Re: Amendment to the Notice of Intent to Commence Large Mining Operations, Denison Mines (USA) Corp., Tony M Mine, M/017/0049, Garfield County, Utah

Denison Mines (USA) Corp. (Denison) is submitting this amendment to the Notice of Intention to Commence Large Mining Operations (the "Notice"), for the Tony M Mine M/017/0049, originally submitted on November 17, 2006 and revised in February, April, May, July, and August 2007, and May 2008. This draft submittal is provided as redline-strikeout.

DETAILED SCHEDULE OF CHANGES TO THE MINING AND RECLAMATION PLAN

FIGURE 5

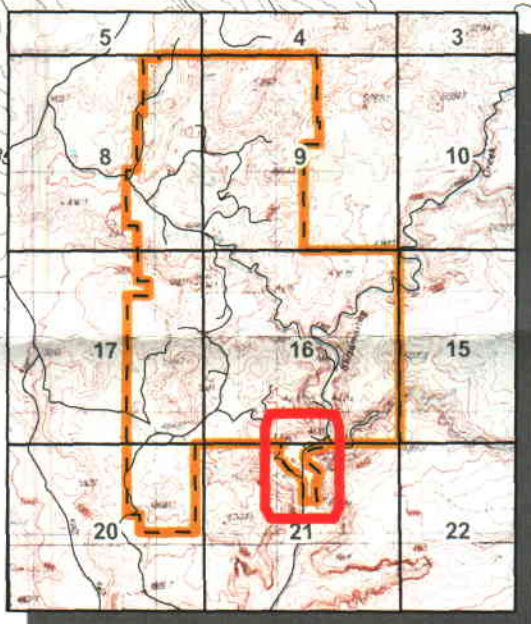
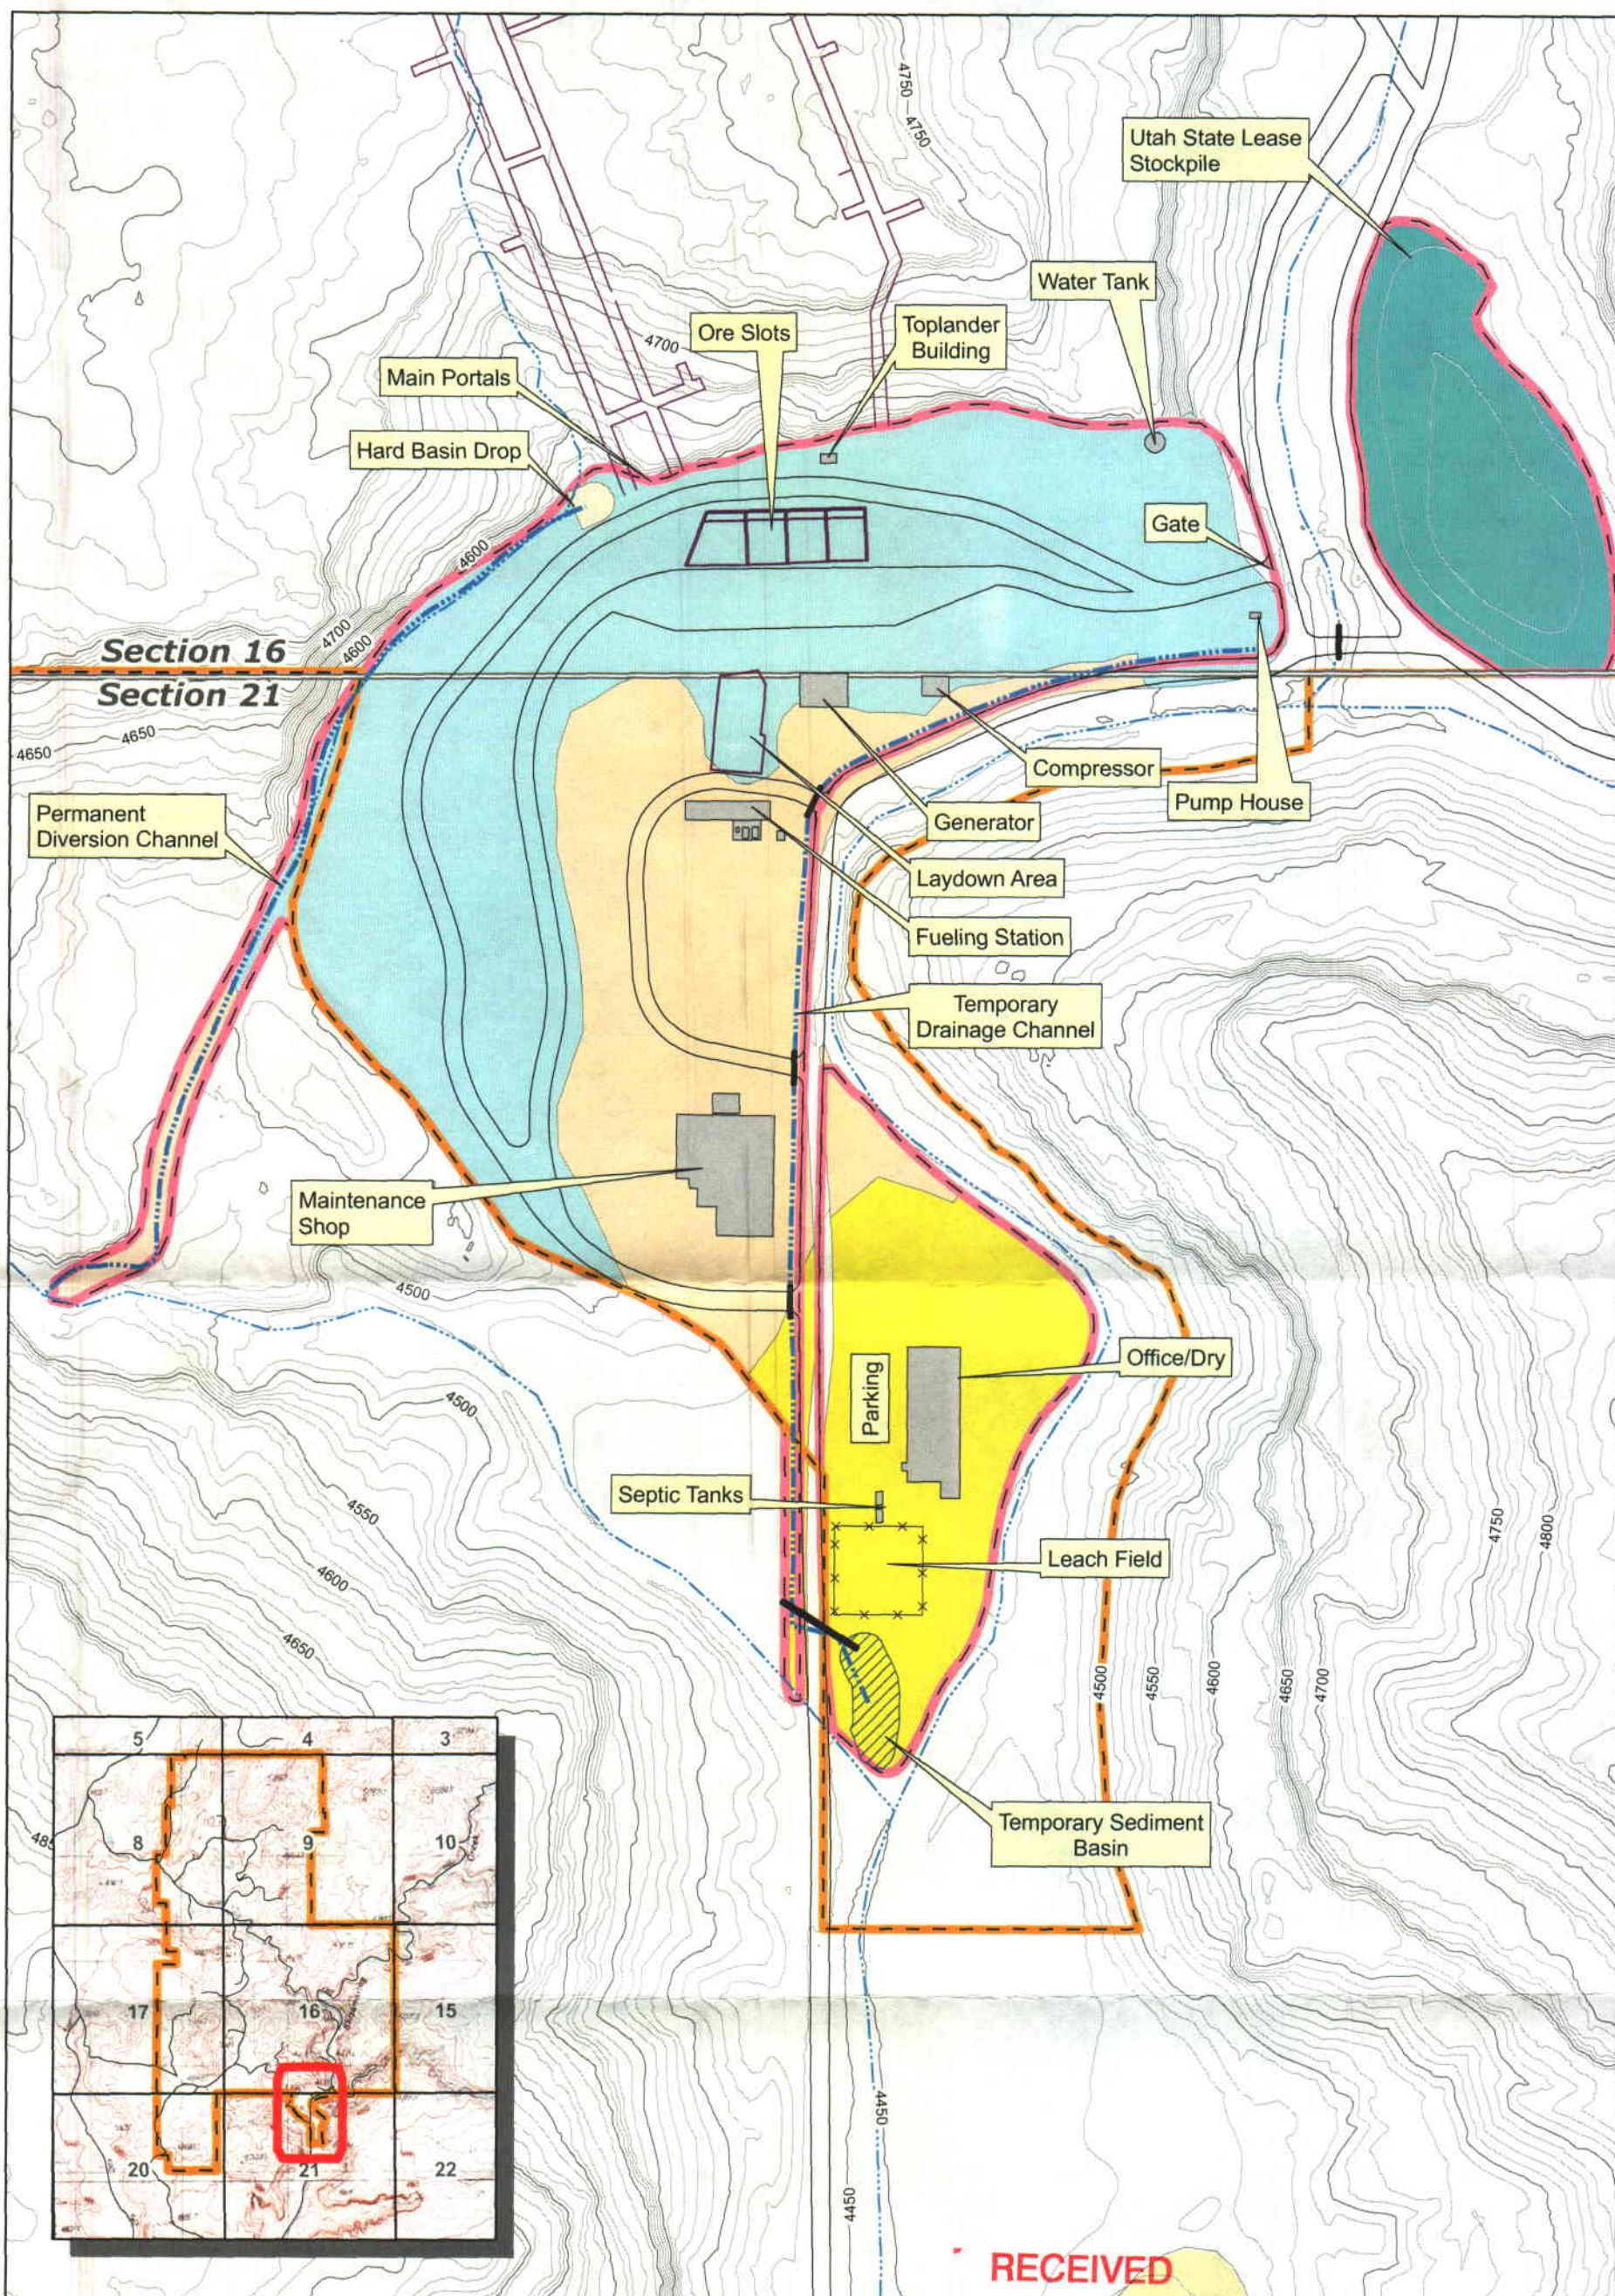
Diesel fuel for the generators (see Figure 5) will be supplied by **two** 850 ~~or 1,700~~-gallon tanks built into the skid-mounted installation. ~~A separate tank of approximately~~ **The two aforementioned** 5,000-gallons **diesel tanks** will provide additional fuel storage and will feed into the skid-mounted tanks. The generator fuel tanks will be located within a bermed and lined area similar to the secondary containment for the fuel station.

Maintenance Shop and Warehouse – A maintenance shop (~~30 feet by 50 feet~~) and warehouse (**approximately 15,650 square feet** ~~30 feet by 30 feet~~) will be constructed as shown on Figure 5. These facilities will consist of prefabricated metal buildings on six-inch concrete pads and will be painted tan or light brown.

Designated Parking and Storage Yards – A gravel parking area will be provided for employees and visitors adjacent to the mine offices as shown on Figure 5. A fenced storage yard (**Laydown Area Storage Yard 1**) will be located on the west side of the county road. The yard will be used to store underground supplies (e.g., roof bolts, mats, pipe, hoses, power cable), mobile equipment, and large replacement parts.

The upper six inches of soil from the reclaimed waste rock area will also be salvaged and placed in **the southwest portion of the** Topsoil Stockpiles TS 2A and TS 2B (see Figure 5) at a maximum height of 8 and 10 feet, respectively. The revegetated waste rock material is not as good a resource as the native soils; however it does support vegetation, as evidenced by the revegetation success to date. The volume of soil available for stripping and stockpiling from the reclaimed 11-acre waste rock area is also estimated to be 9,000 bcy.

FIGURE 7
Topsoil Stripping Map

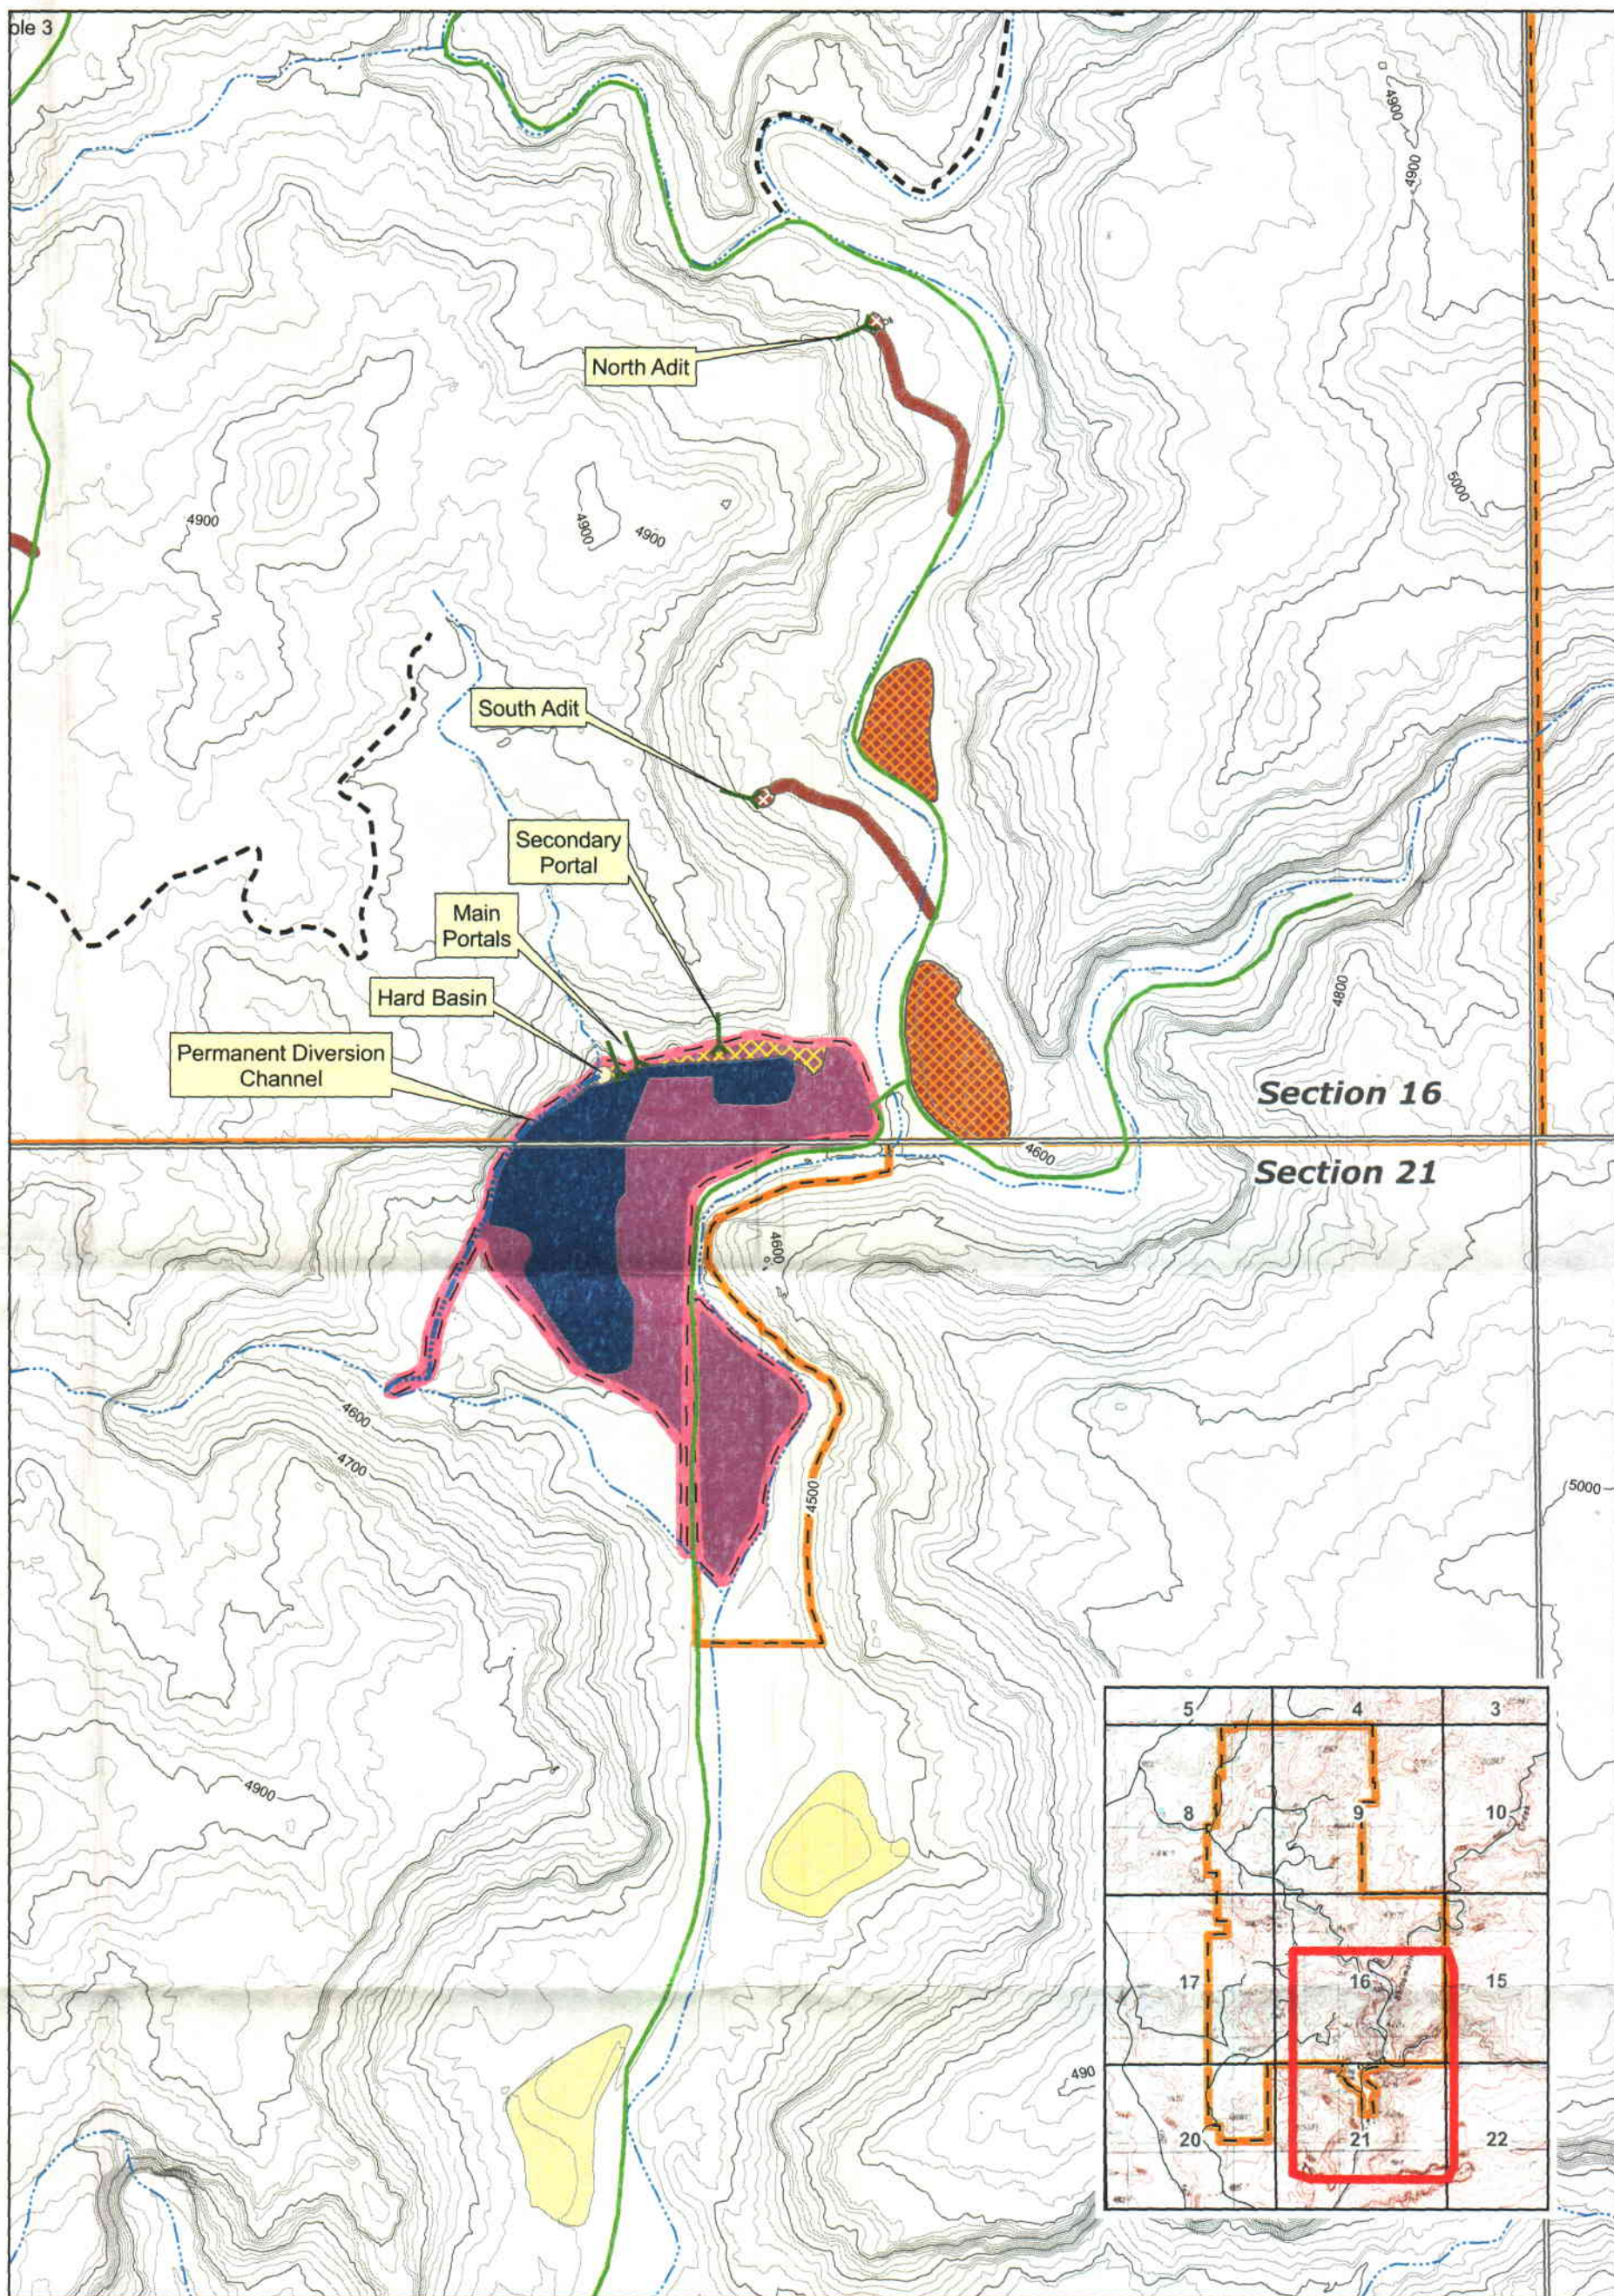
Figure 7 presents the topsoil-stripping map for the portal area. As shown, the **topsoil in the southern** portion of the proposed disturbed area **was washed away during a flood, therefore, there is no** ~~between 10 and 15 inches of~~ **strippable soil in that area., and** ~~the~~ **The central portion has between 5 and 10 inches of strippable soils.** Most of these soils are of the Neskahi Series. If **an** ~~average~~ **average soil depths of 12.5 inches and 7.5 inches** ~~is~~ **are** assumed over the **7.3 ~~11.4~~ acre** area of native soils, the volume of soil available for stripping and stockpiling would total **7,400 ~~16,000~~ bank cubic yards (bcy).** However, topsoil will not be stripped from buffer areas next to the drainages, ~~the leach field,~~ or the topsoil stockpile areas. Soil stripping efficiencies will also be relatively low in those areas where the soil is thinner or intermixed with gravel and rock. Given these considerations, a strippable volume of approximately 9,000 **4,500** bcy is projected for the area. These soils will be placed in **the** Topsoil Stockpiles (TS) ~~1 and TS 3, 4, and 5~~ (see Figure 5). **The** ~~Stockpile heights was were~~ **Stockpile heights** ~~was were~~ **driven by land area limitations and TS 1 and TS 2B will have a maximum height of about 10 feet due to land area limitations. TS 2A and TS 3 can be 8 feet, and TS 4 and TS 5 will be 6 feet.**
